L-2015-205
10 CFR 52.3

Re: Florida Power & Light Company
Proposed Turkey Point Units 6 and 7
Docket Nos. 52-040 and 52-041
Voluntary Response for FPL COL Application, Part 2, FSAR Chapter 3,
Subsection 3.7.2.8 – Interaction of Seismic Category II and Nonseismic
Structures with Seismic Category I Structures, Systems, or Components

FPL Voluntary Response for the Interaction of Category II and Nonseismic Structures on Category I Structures

Figure 1 Postulated Void Conditions under Turbine Building

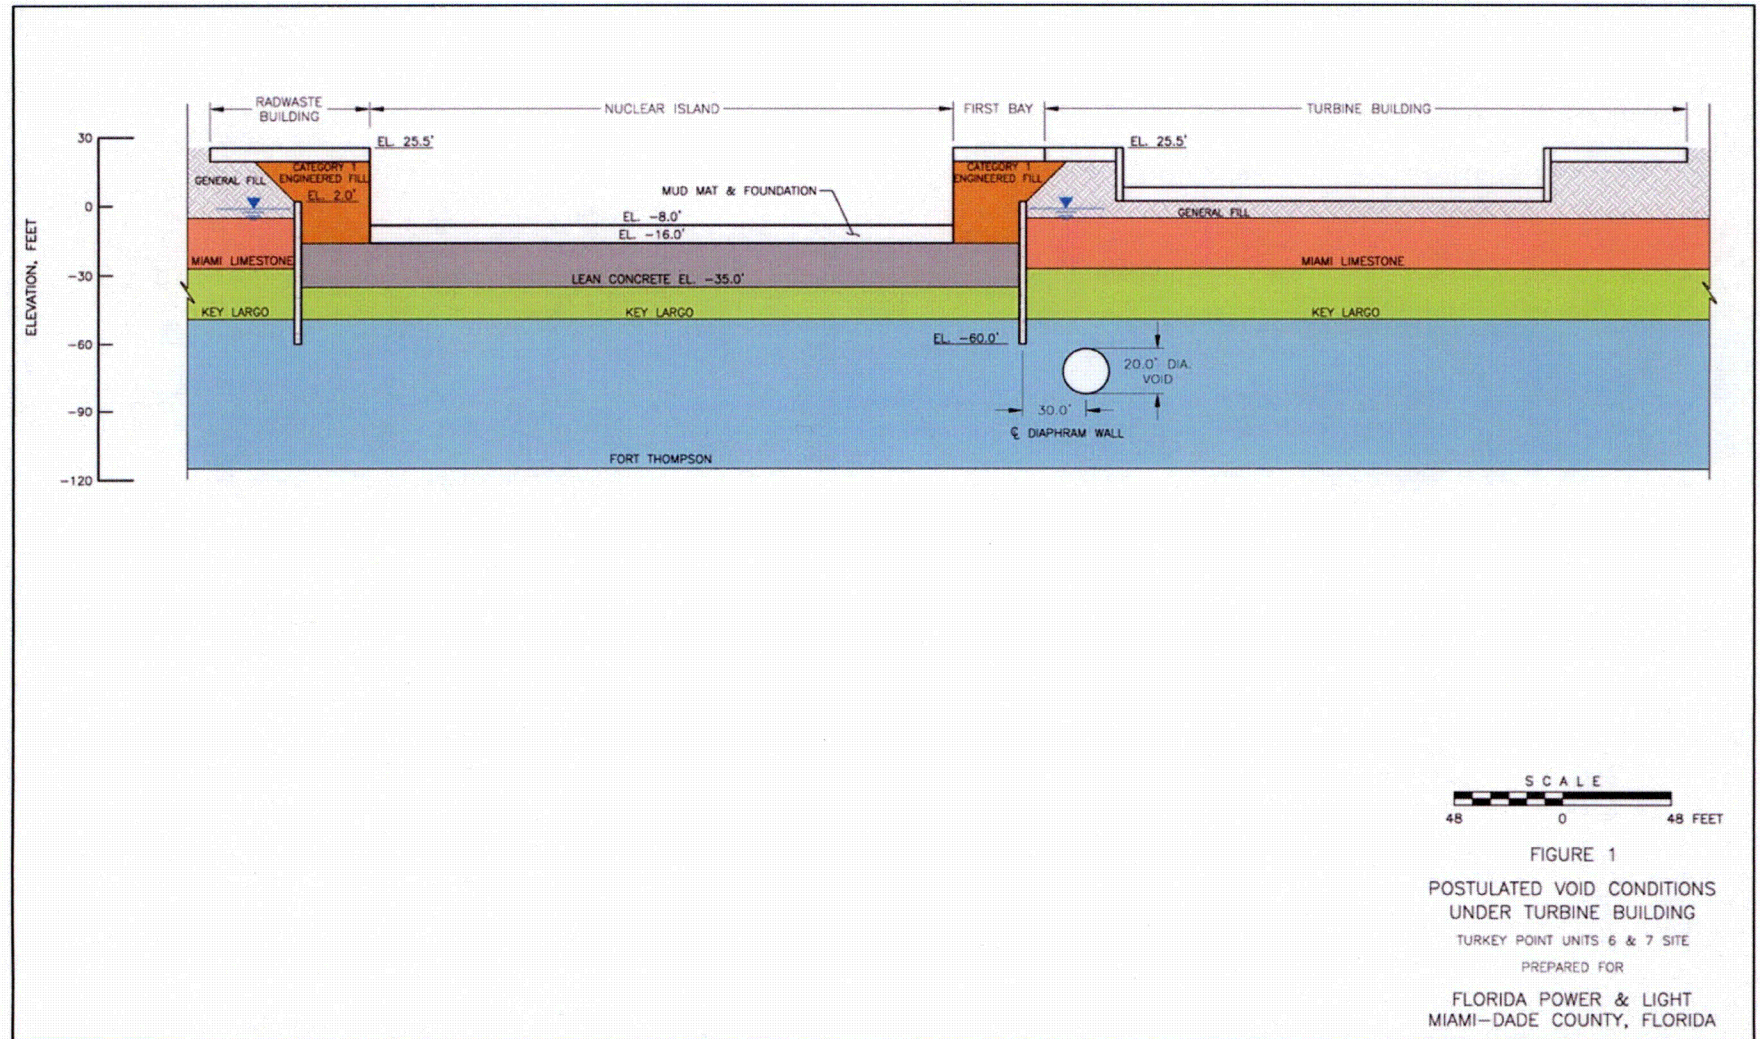
During the technical audit conducted between June 22, 2015 and June 25, 2015, NRC staff raised the question about the safety evaluation of Category II and non-seismic structures under postulated void conditions from the perspective of the potential impact of collapse of these structures on the Category I structure.

As discussed earlier, large voids (>5 feet) are not anticipated to be present under Category II or non-seismic structures. However, an analysis has been conducted to evaluate the safety of these buildings under postulated void conditions that are similar to those considered for the nuclear Island. According to this, a tunnel (cylindrical) shaped void with a 20-foot diameter is considered underneath the Category II and non-seismic structures with the top of the void at El. -60 feet. For this postulated void condition, the most critical building is considered to be the turbine building given the magnitude of the static and seismic loads for this building. The evaluated condition is shown in Figure 1.

Figure 3.7-203 PLAXIS3D Sensitivity Model with 20-foot Diameter Cylindrical Void

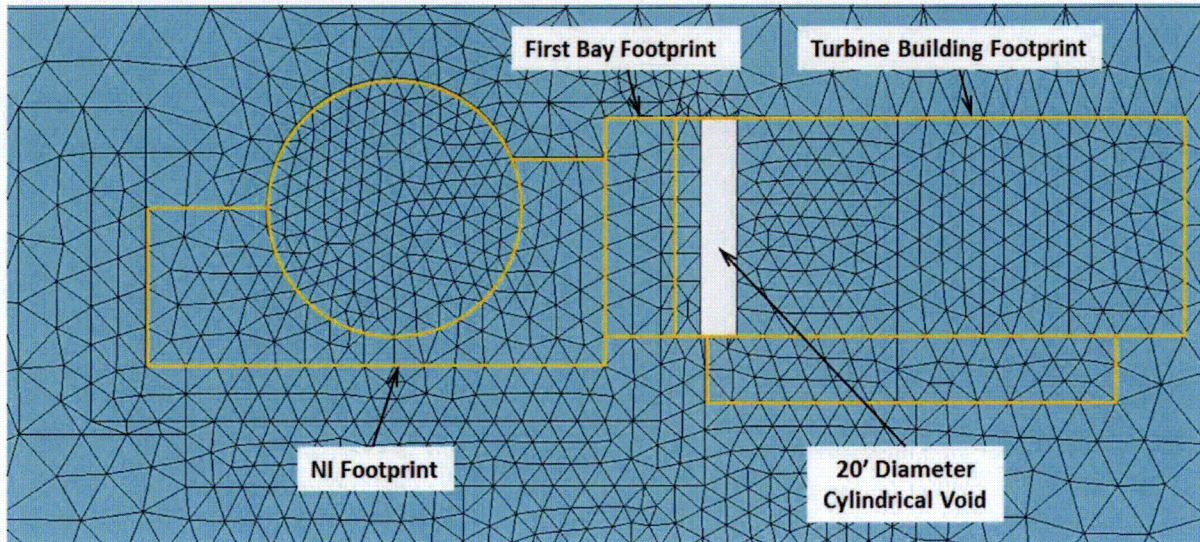
The following figures will be added to Subsection 3.7 in a future revision of the COLA:

Figure 3.7-203 shows the PLAXIS3D model. The 3D mesh is refined to the extent possible in the area surrounding the void. The total number of elements is 104,760.
